WAYZATA PLANNING COMMISSION

Monday, August 2, 2021

MEETING DATE: August 2, 2021	AGENDA ITEM: 5.a
TITLE: Consider Development Application for Planned Unit Development Amendment and Design Deviations for Moments of Wayzata at 163 Wayzata Blvd W	
PREPARED BY: Eric Zweber, Planning Consultant	
REVIEWED BY: Emily Goellner, Community Development Director	
60 DAY DEADLINE: August 29, 2021

**Staff Report
Wayzata Planning Commission
August 2, 2021**

C3.3
Page 210 of 266
SHEET NUMBER

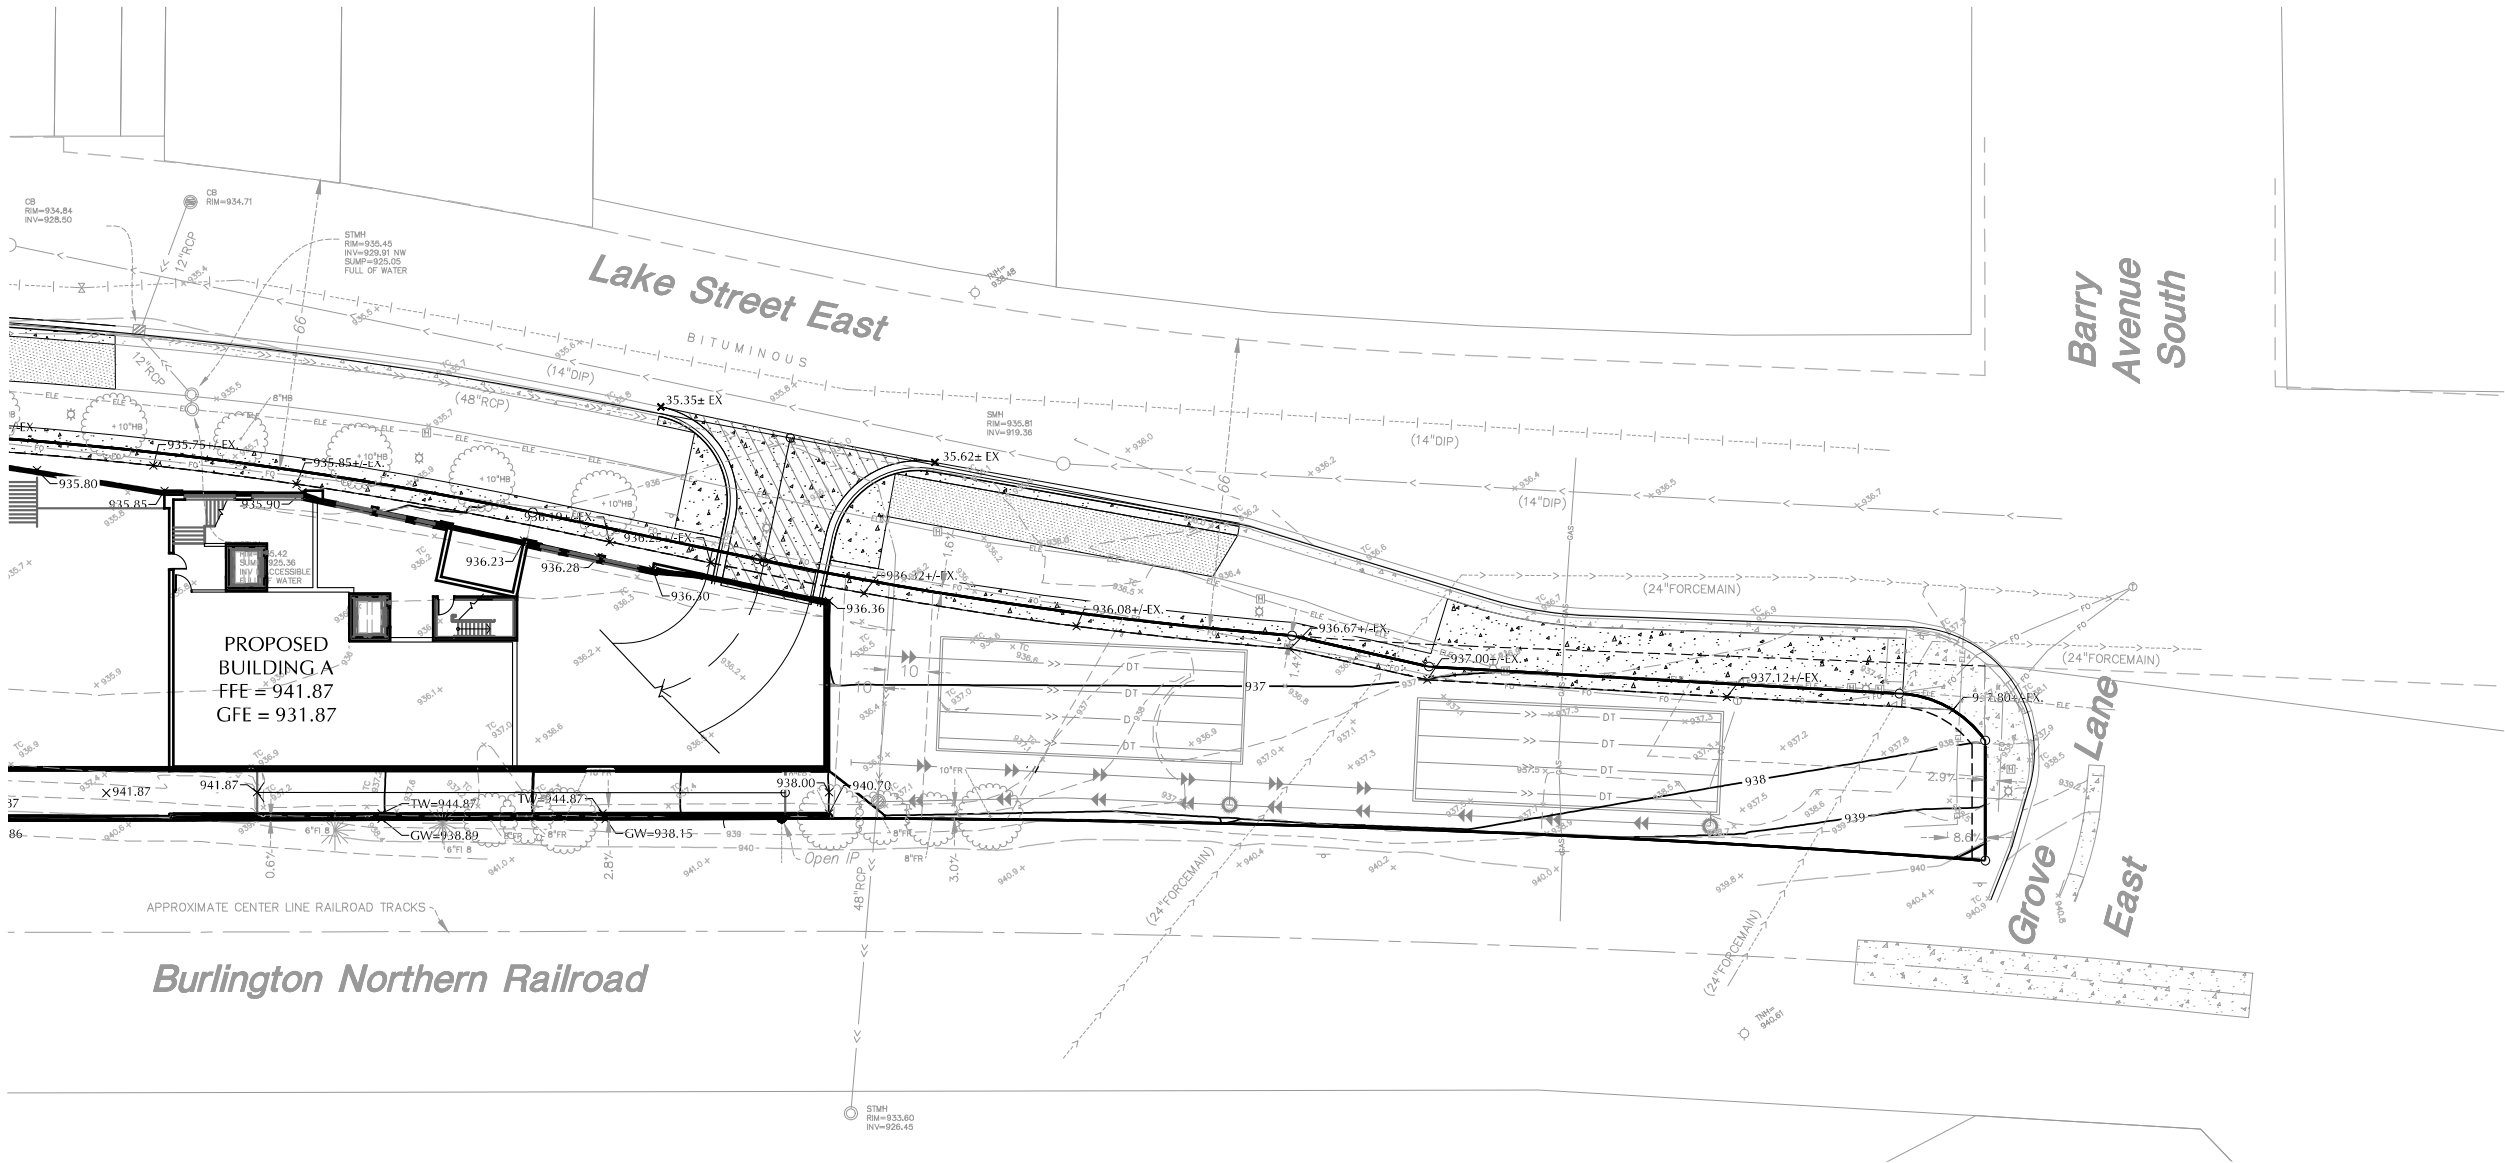
Response: The grading plan has been clarified to illustrate the connection between the East Park and the East Plaza. In addition to the connection, an elevator is provided, and all applicable building codes will be met. (Refer to sheet(s) C3.3)
